Approval of a Public Improvement Contract with Colton Construction for the Rugg Road Landslide, MP 0.70 Project. Total contract value is \$879,182.66 over 21 months. Funding is through Damascus Road Funds. No County General Funds are involved.

Project Name: # 2024-02 Rugg Road Landslide, MP 0.70 Project

INVITATION TO BID #2024-02
Rugg Road Landslide, MP 0.70 Project
ADDENDUM NUMBER 1
January 24, 2024

Sheet No. **WA03**

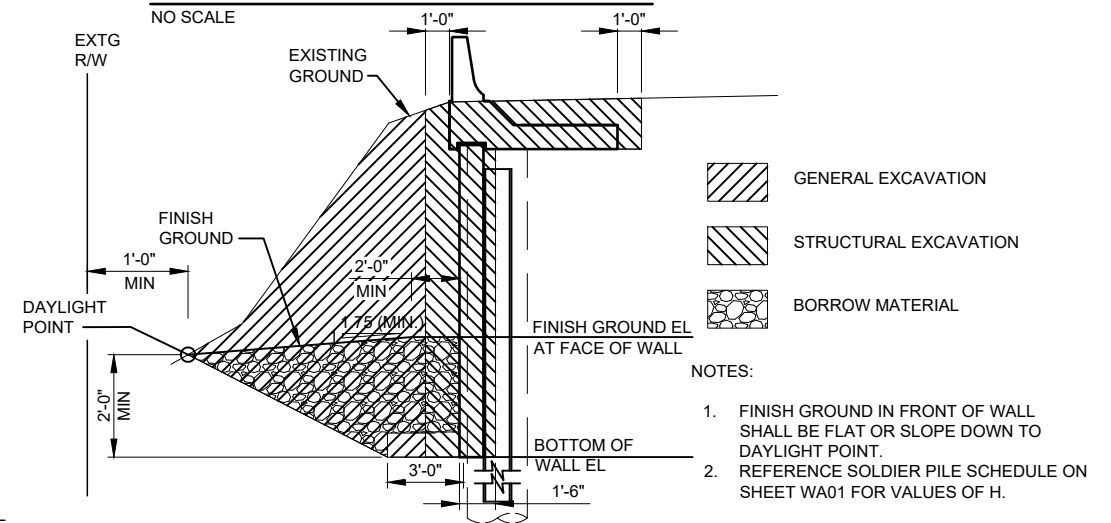
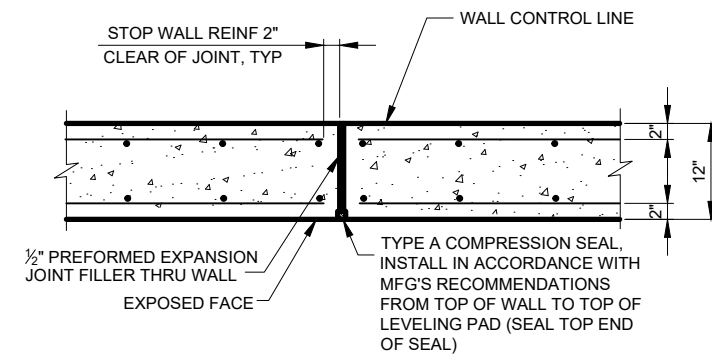
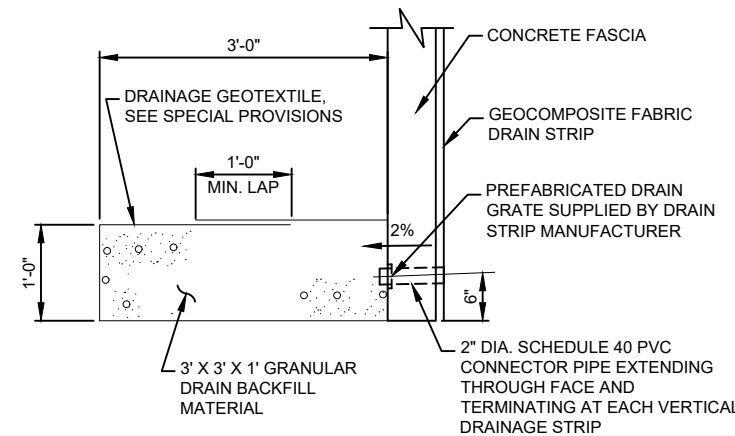
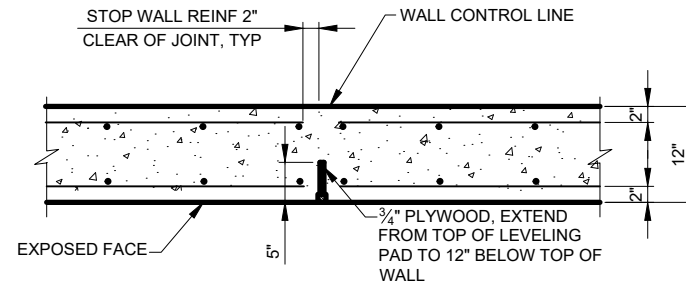
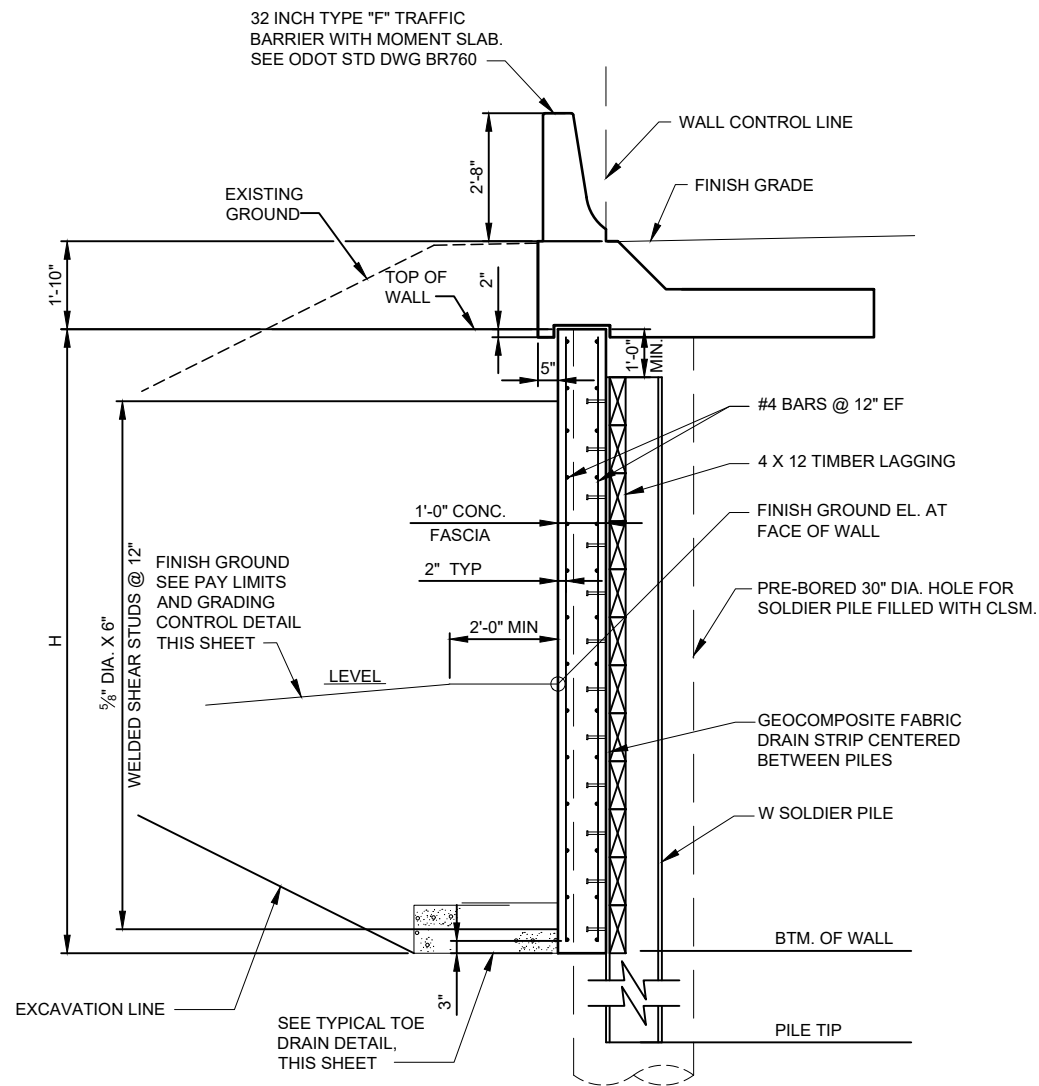
- **Question #3:** The Wall Details sheet WA03 has a callout to refer to ODOT STD DWG BR760 for the 32 INCH Type “F” Traffic Barrier with Moment Slab. The standard drawing BR760 shows the width of the moment slab to be 7’-0” minimum. Is this moment

slab being constructed at that minimum width or at a wider width? Please provide dimensions for the width of the moment slab.

- **Response #3:** The moment slab is being constructed at the minimum 7' width as shown in BR760.
- **Commentary #3:** As shown in the "CROSS-SECTION" detail, ' 2'-0" Design thickness ' is correct, i.e. The concrete slab is 12"(inches_ and the HMAC 'overburden' is 12"(inches).

PAVING & GUARDRAIL DETAILS

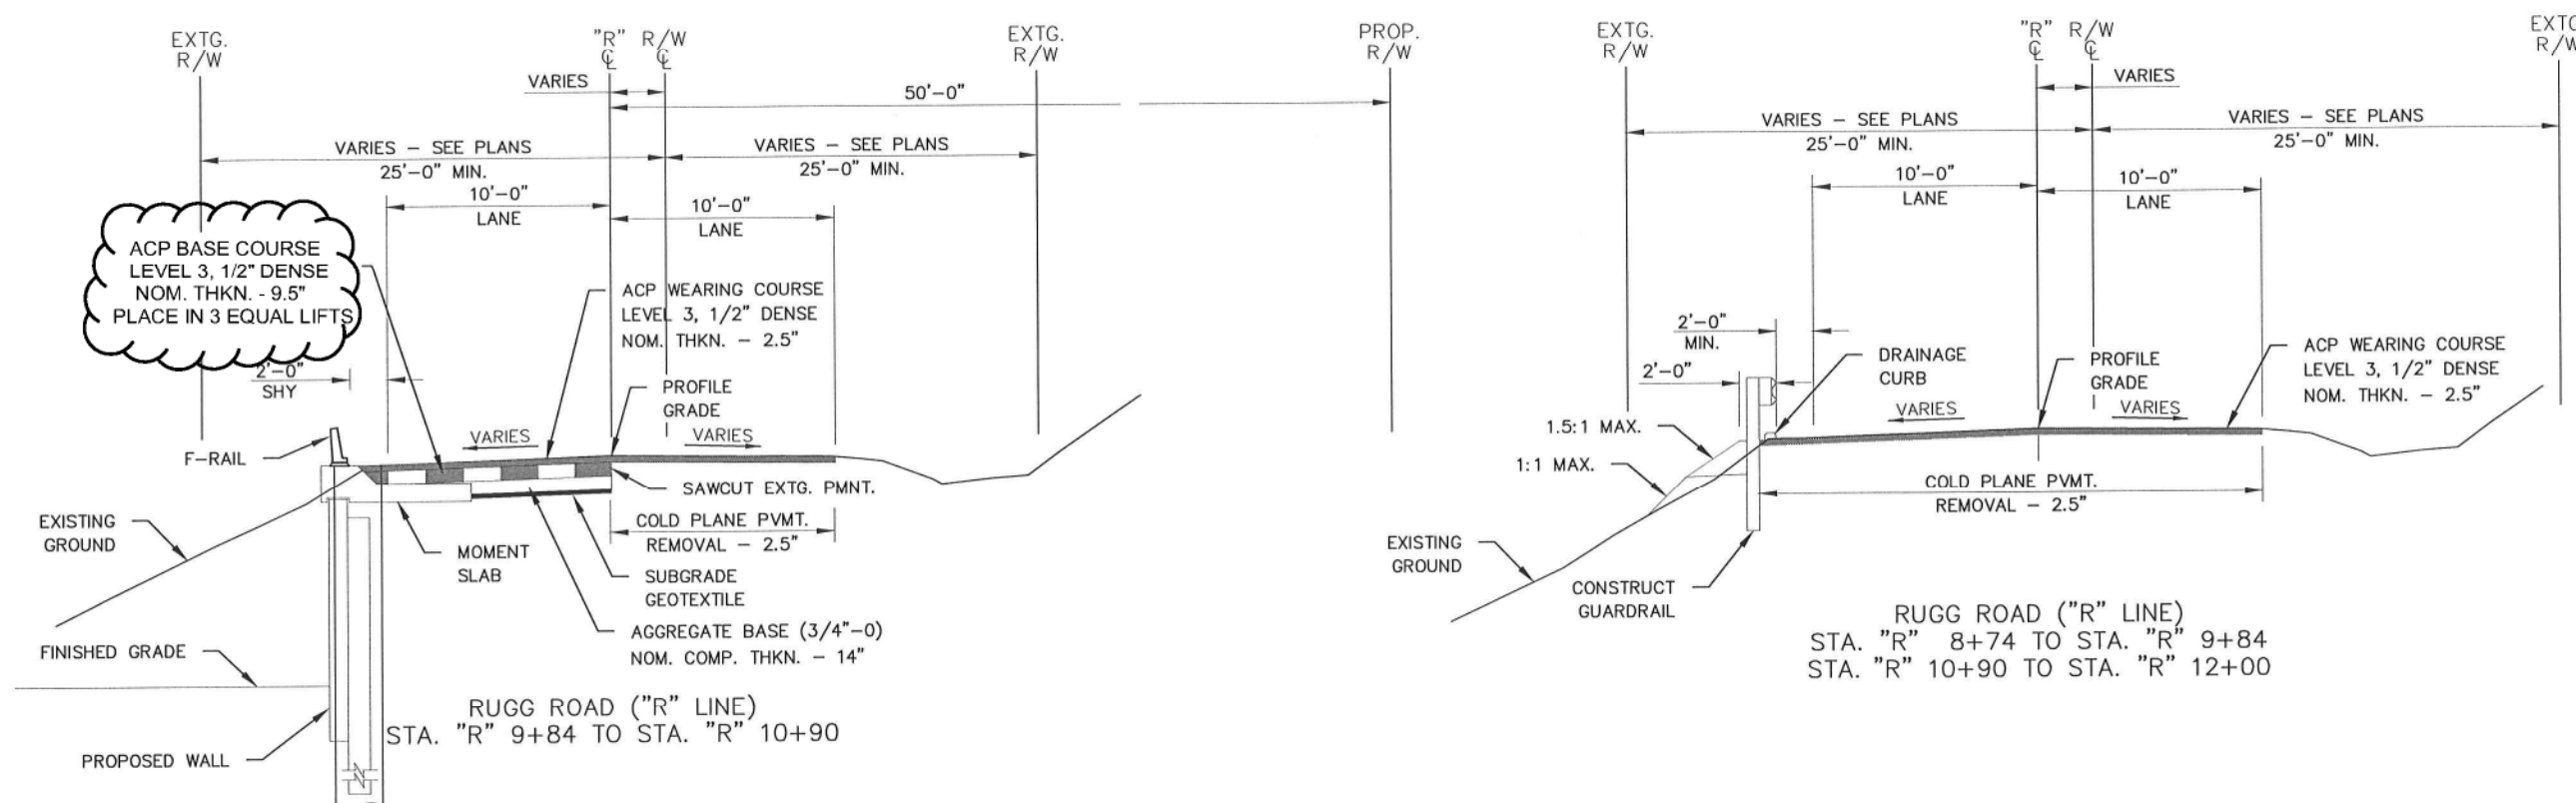
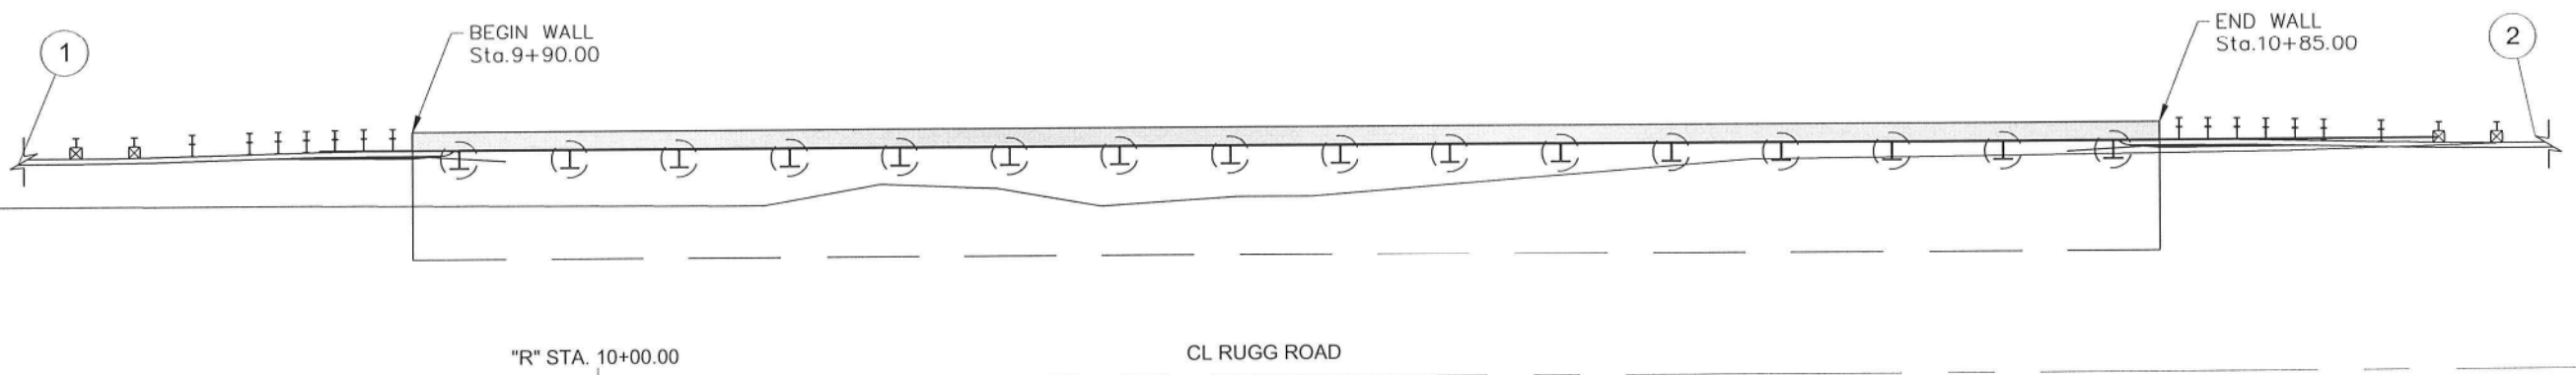
- **Question #4:** The ODOT Standard Drawing BR760 also dimensions 1'-0" of Required overburden using HMAC or CLSM. The HMAC section shown on plan sheet GR01 is only 7.5". Please provide clarification on the material to be used for the remaining 4.5" of overburden on top of the moment slab and applicable pay item.

- **Response #4:** Plan Sheet GR01 has been replaced and updated to show correct ' 9.5" of ACP/HMAC Base Course ' underlying a ' 2.5" of ACP Wearing Course '.
